Access Compliance Report

Public Rights-of-Way

(Curb Ramps)

Intersection ID: 12413	Main Street: N_BREVARD_ST	Cross Street: E_6TH_ST	Location: W
ADA ID: 9E02DEF7A610	Ramp Type: Perp	Initial Pass/Fail: Fail	Overall Compliance: No
		Severity Score: 12.5

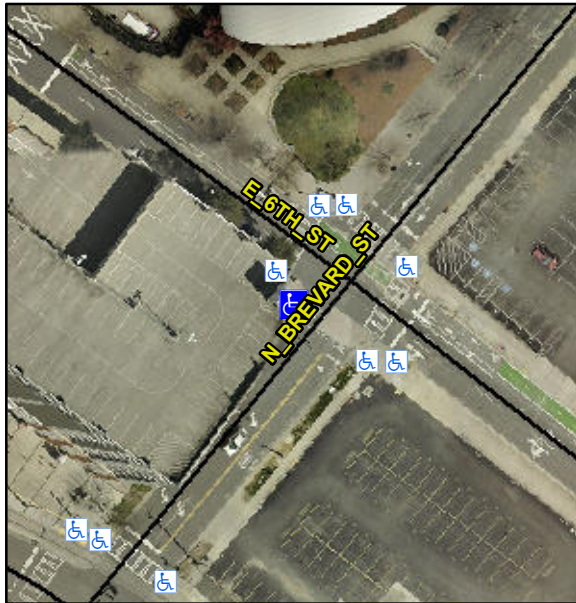
Not Found, R304.2.2

Compliance	Description	Data	Compliance	Description	Data
N/A	Ramp Length (in)	72.0	No	Ramp Slope (%)	8.7
Yes	Ramp Width (in)	48.0	Yes	Ramp XSlope (%)	1.7
N/A	Flare Type LT	N/A	N/A	Flare Type RT	N/A
N/A	Flare Slope LT (%)	N/A	N/A	Flare Slope RT (%)	N/A
N/A	Flare Traversable LT?	N/A	N/A	Flare Traversable RT?	N/A
N/A	Landing Length (in)	N/A	N/A	DWS Provided?	N/A
N/A	Landing Width (in)	N/A	N/A	DWS Contrast?	N/A
N/A	Landing Slope (%)	N/A	N/A	DWS Length (in)	N/A
N/A	Landing X Slope (%)	N/A	N/A	DWS Full Width?	N/A
N/A	Landing Curb? (Y/N)	N/A	N/A	DWS Offset (in)	N/A
N/A	Shared Landing?	N/A			
N/A	Gutter Ponding?	N/A	N/A	Gutter Slope (%)	N/A
N/A	Gutter Lip Ht (in)	N/A	N/A	Gutter X Slope (%)	N/A
N/A	Painted X Walk1?	Yes	N/A	Painted X Walk2?	N/A
	X Walk 1 Direction	To SE		X Walk 2 Direction	N/A
N/A	X Walk 1 Width (in)	112.0	N/A	X Walk 2 Width (in)	N/A
	X Walk 1 Slope (%)	0.9		X Walk 2 Slope (%)	N/A
	X Walk 1 X Slope (%)	2.1		X Walk 2 X Slope (%)	N/A

Remove & Replace Entire Ramp.
